PROJECT PLANS FOR CONSTRUCTION ON
STATE HIGHWAY
IN EL DORADO AND PLACER COUNTIES AT AND NEAR TAHOE CITY FROM 0.2 MILE SOUTH OF THE EL DORADO/PLACER COUNTY LINE TO THE TRUCKEE RIVER BRIDGE

4 REVISED PER ADDENDUM No. 4 DATED MARCH 2, 2012

CONTRACT No.	03-2A9204
PROJECT ID	0300000297

SV DETAILS No. 3

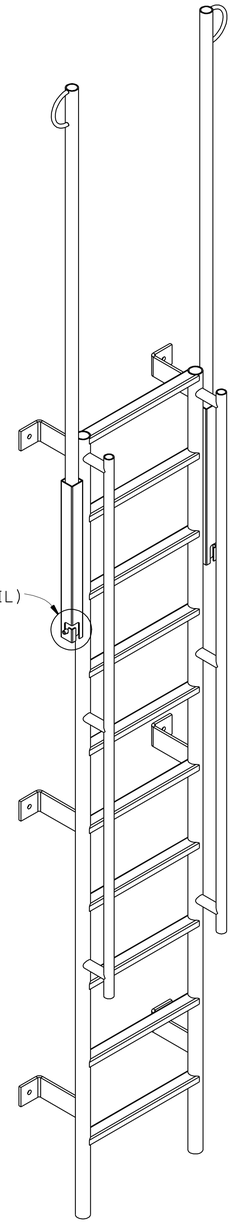
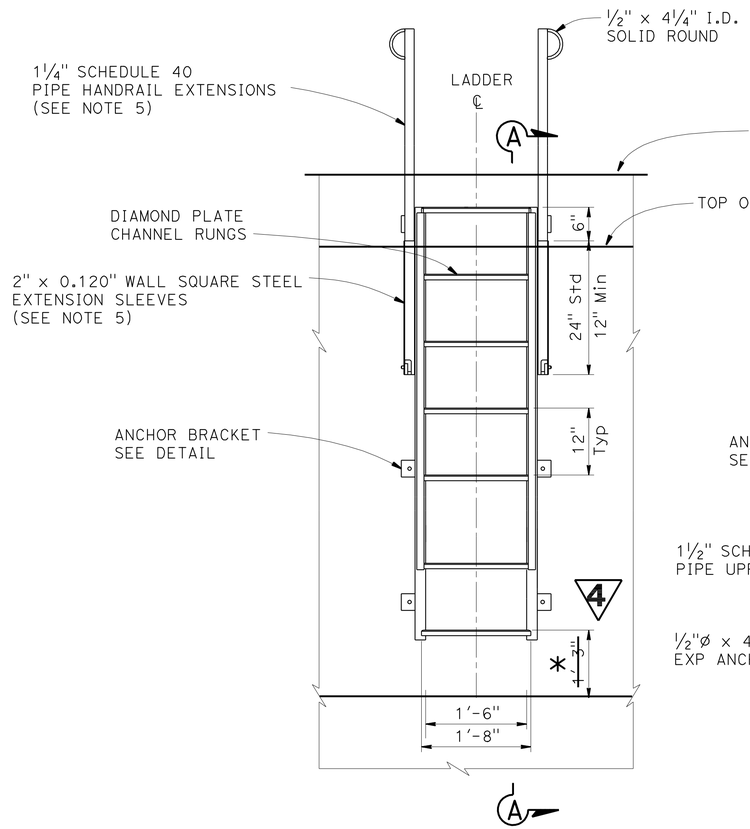
4 * 1'-0" INLET CHAMBER
1'-3" OUYLET CHAMBER

4 **REVISED PER ADDENDUM No. 4 DATED MARCH 2, 2012**

SAND TRAP (TYPE PI)

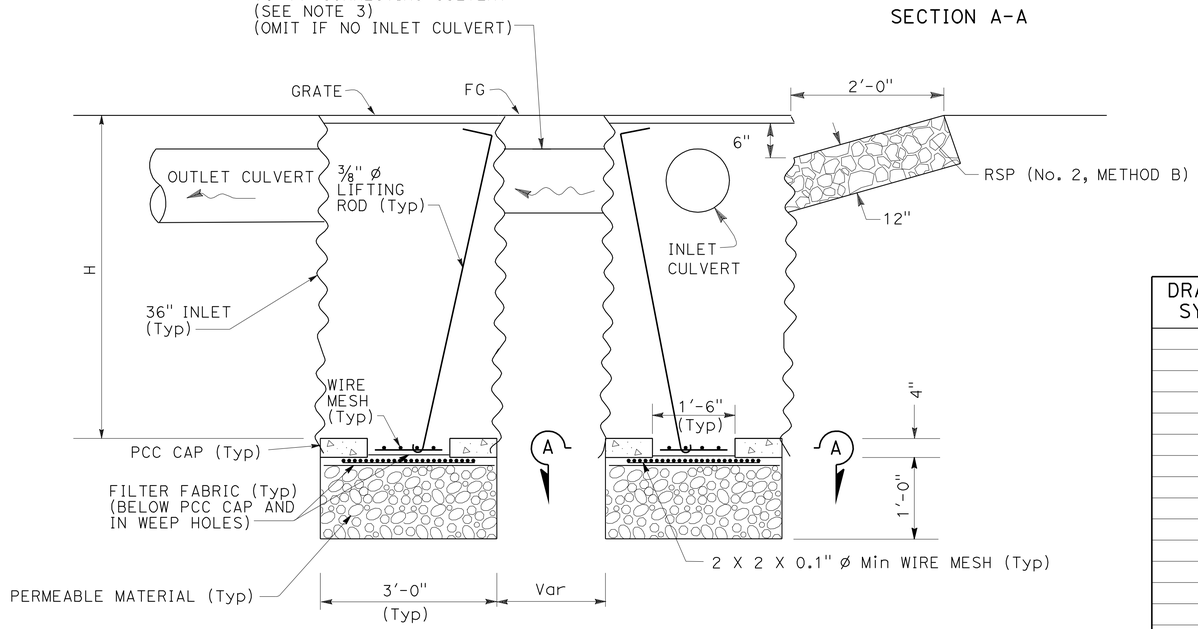
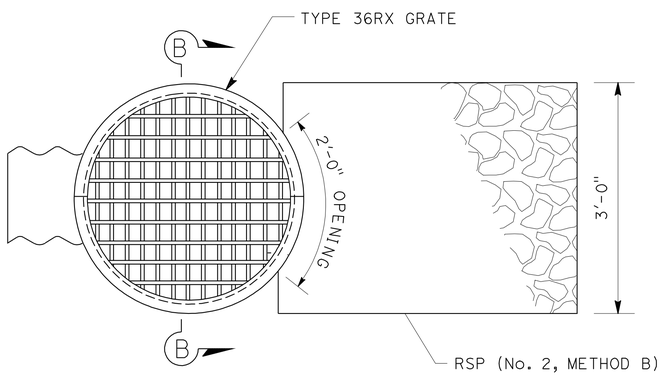
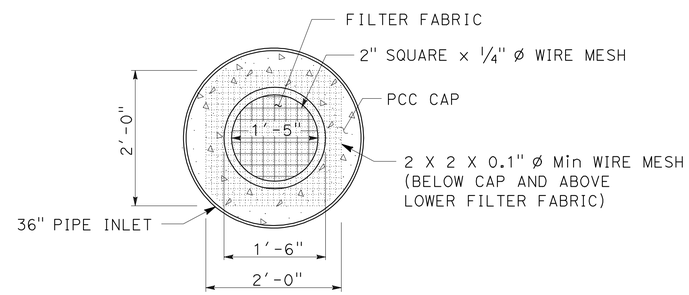
4 **REVISED PER ADDENDUM No. 4 DATED MARCH 2, 2012**

DD-26

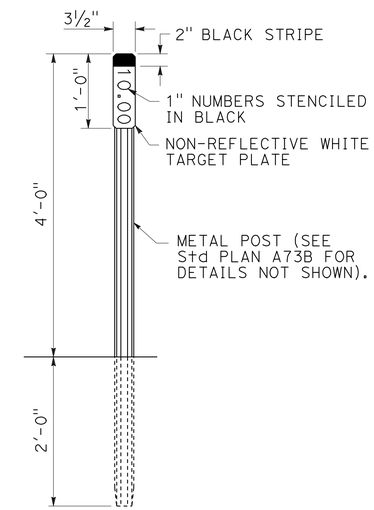
4 DRAINAGE INLET MARKER

4 REVISED PER ADDENDUM No. 4 DATED MARCH 2, 2012

NOTE: DRAINAGE INLET MARKERS TO BE PLACED AT ALL DRAINAGE INLETS AND SAND TRAPS EXCEPT GMP(MOD) INLET AND SAND TRAP (TYPE PI). TYPE OF MARKER SHALL BE STAMPED CONCRETE IMPRINT.
